ADDENDUM

ADDENDUM NO.: 01
PROJECT NAME: Sheridan Elementary School Annex
PROJECT NO.: 05075
CONTRACT NO.: C1581
DATE OF ISSUE: September 1, 2017

NOTICE OF CHANGES, MODIFICATIONS, OR CLARIFICATIONS TO CONTRACT DOCUMENTS

KEY - FOR WALL PAINT COLORS	
SOLID	—————
2 COLORS (SEE ELEVATIONS)	—————
PT-1 TWISTED OAK PATH	—————
PT-2 BLUE	—————
PT-3 INTENSE WHITE	—————
PT-4 LION HEART	—————
PT-9 HONOLULU BLUE	—————

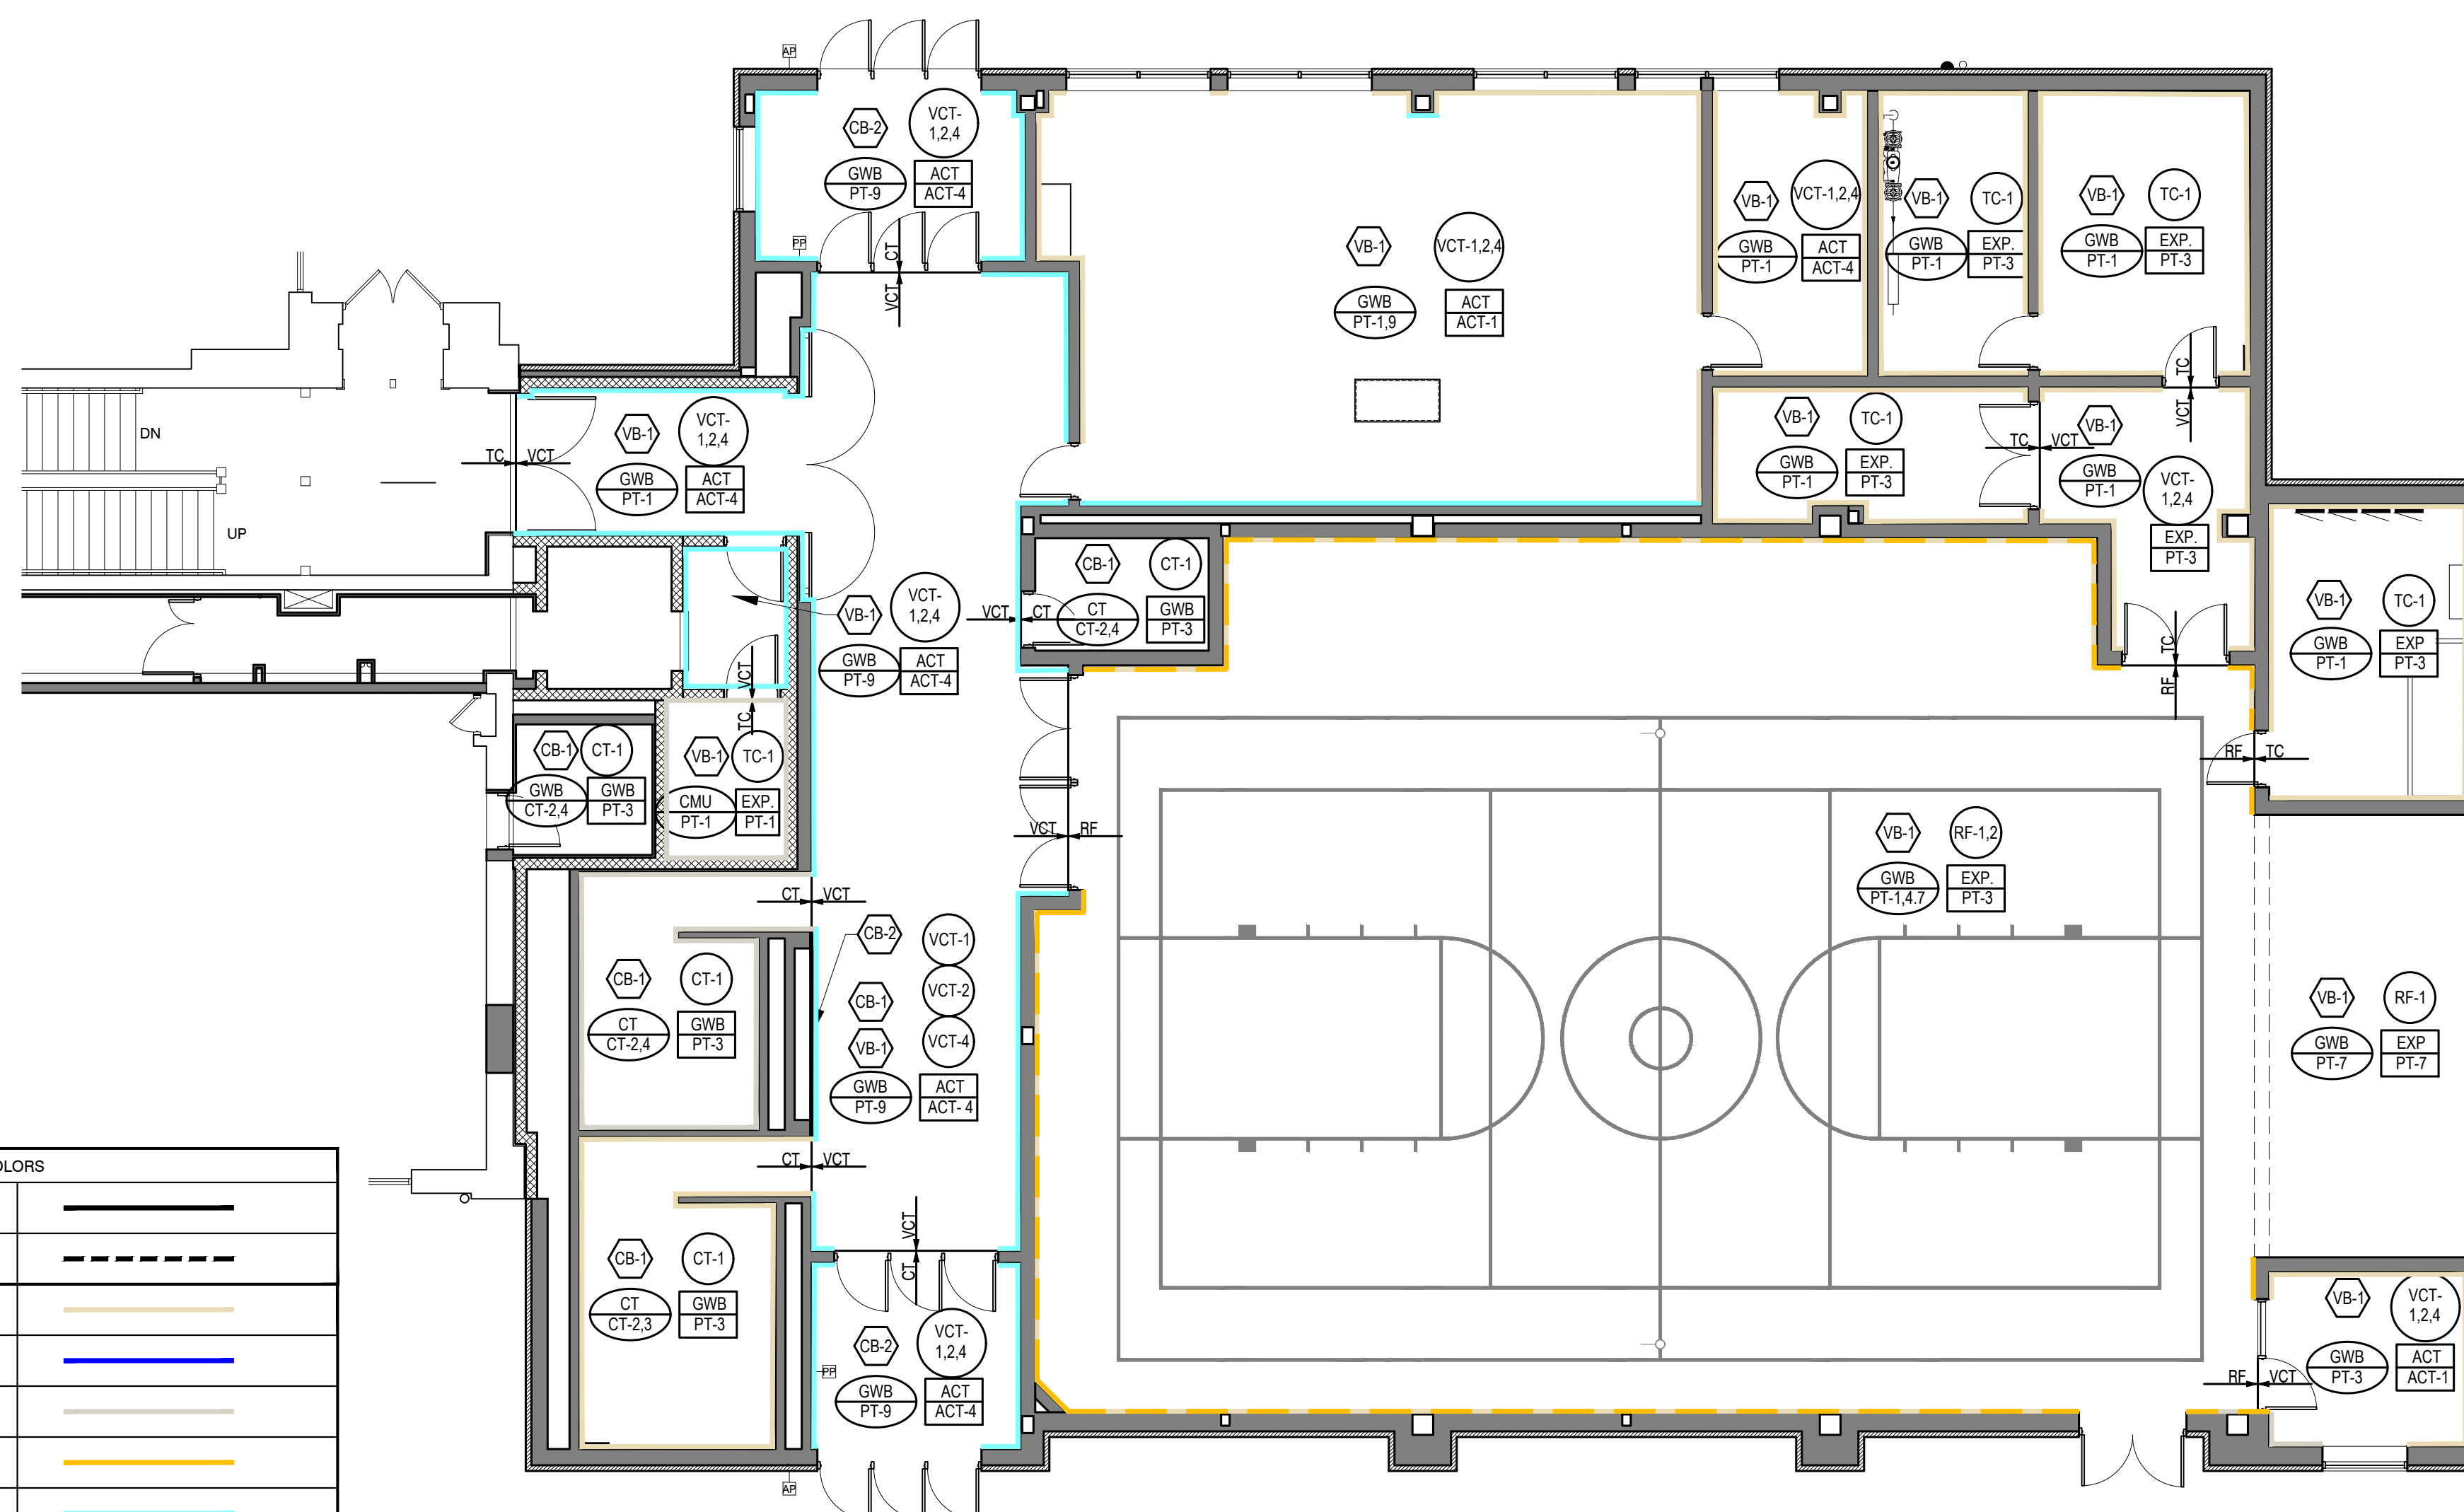
- Change 12. REVISED** – Drawing No. A71 – FIRST FLOOR FINISH PLAN: Revised ACT type from ACT “1” to ACT “4” in details 03, 04, 05 and 06. Enlarged elevator plans to match Finish schedule.

1 EROSION CONTROL PLAN
SCALE: 1" = 20'

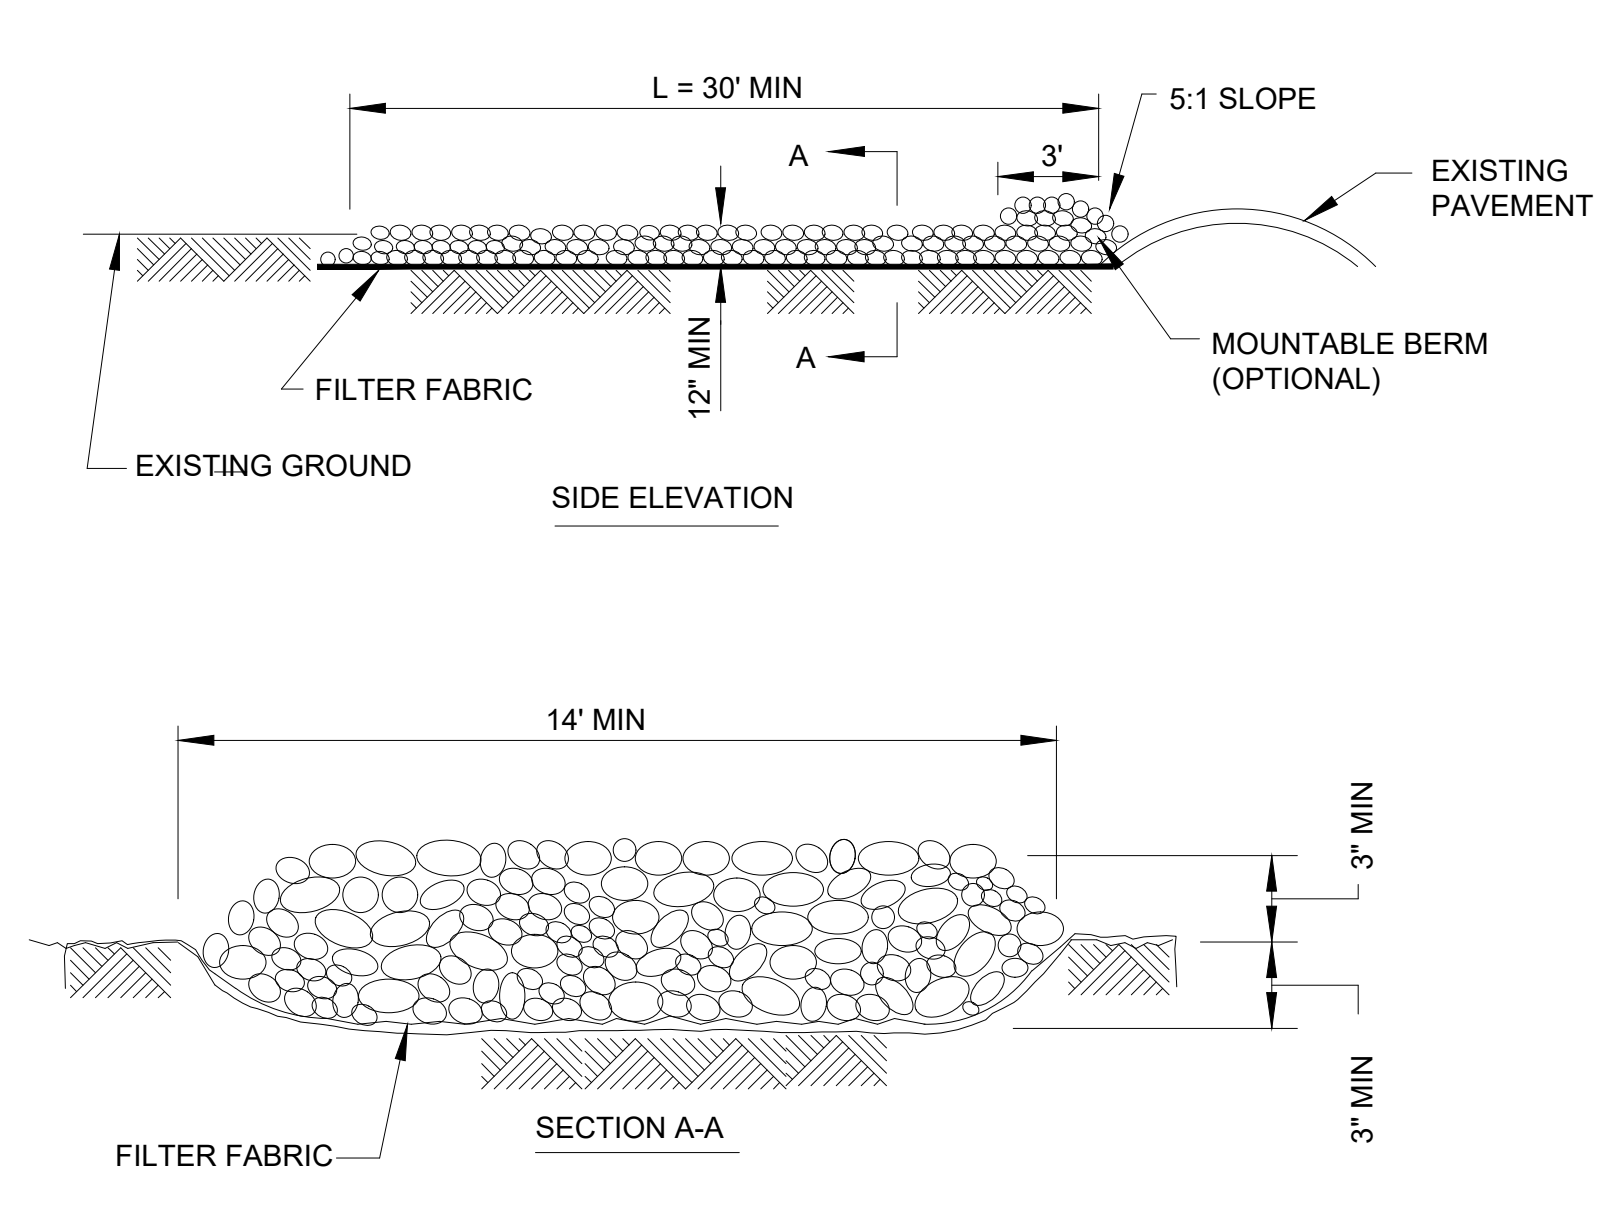
Change 1. REVISED – Drawing No. C31 – EROSION AND SEDIMENTATION CONTROL PLAN: Revised 4” sanitary service invert to 6.61, and the invert of COMB MH-19 was lowered to 6.21 CCD

TITLE:
FIRST FLOOR ELECTRICAL POWER PLAN
 SHEET
EP01

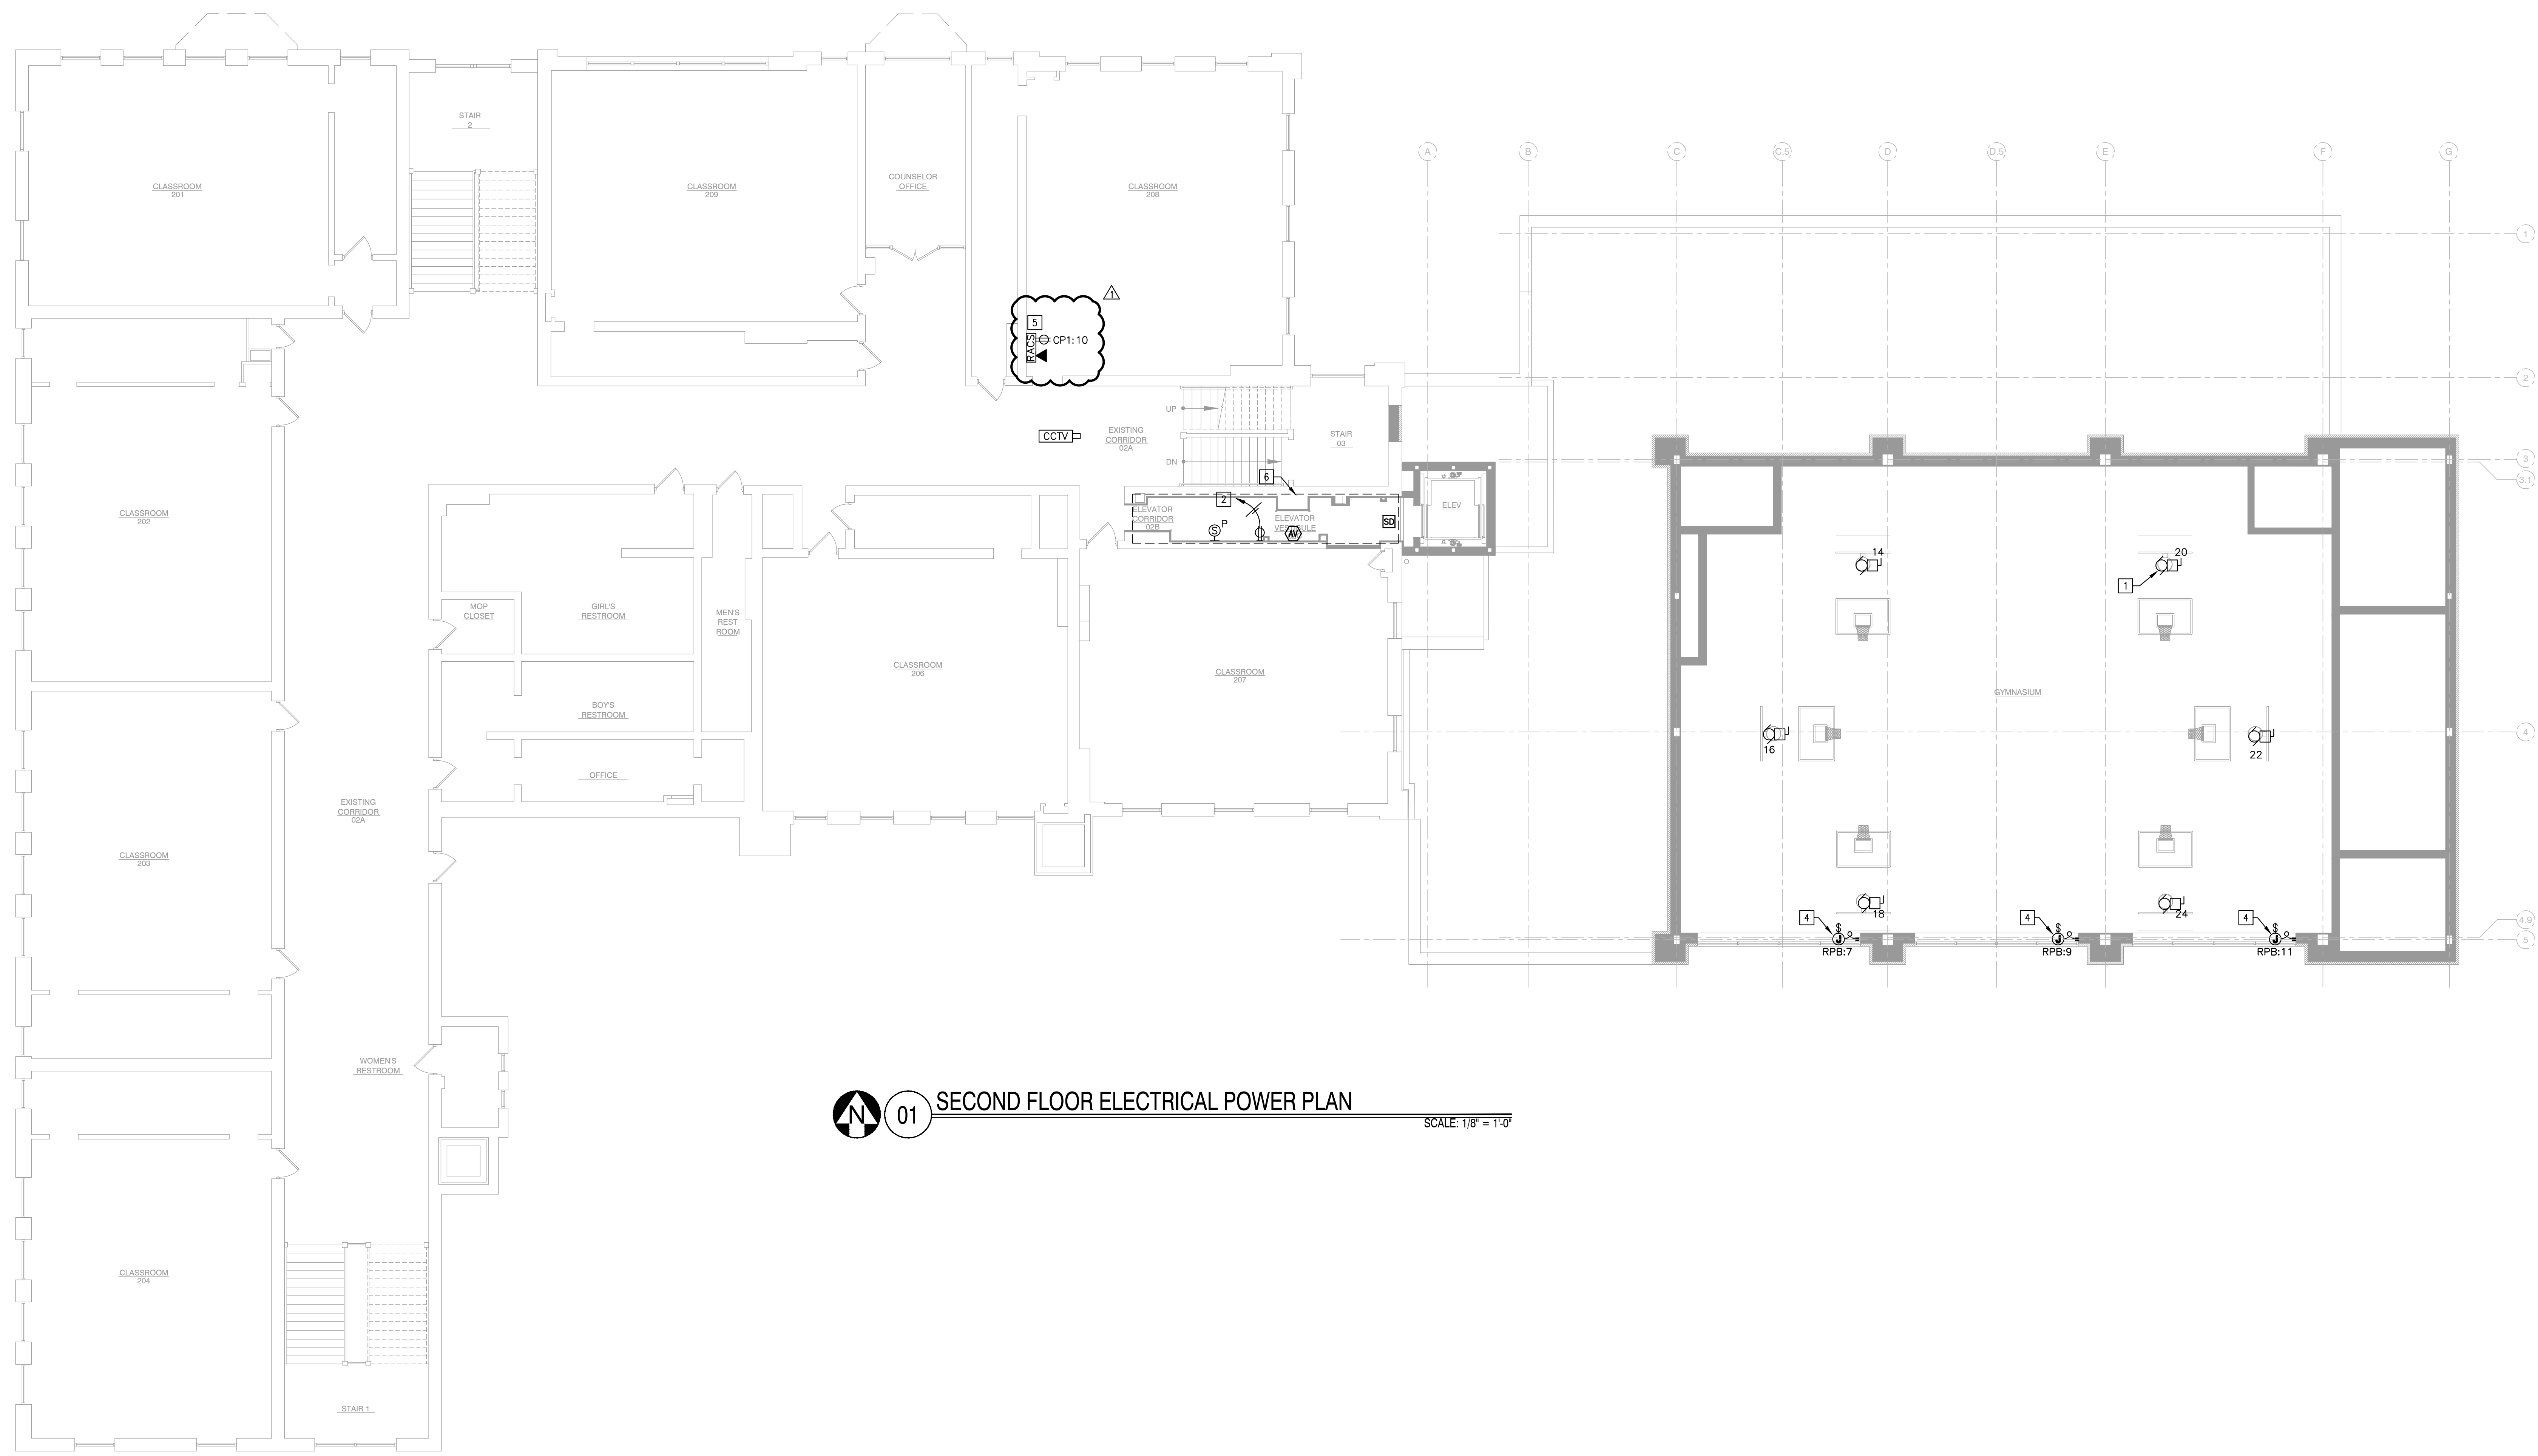
- Change 16. REVISED** – Drawing No. EP01 – FIRST FLOOR ELECTRICAL POWER PLAN: Relocated the Area of Rescue in Classroom 108
- Change 17. REVISED** – Drawing No. EP02 – SECOND FLOOR ELECTRICAL POWER PLAN: Relocated the Area of Rescue in Classroom 208
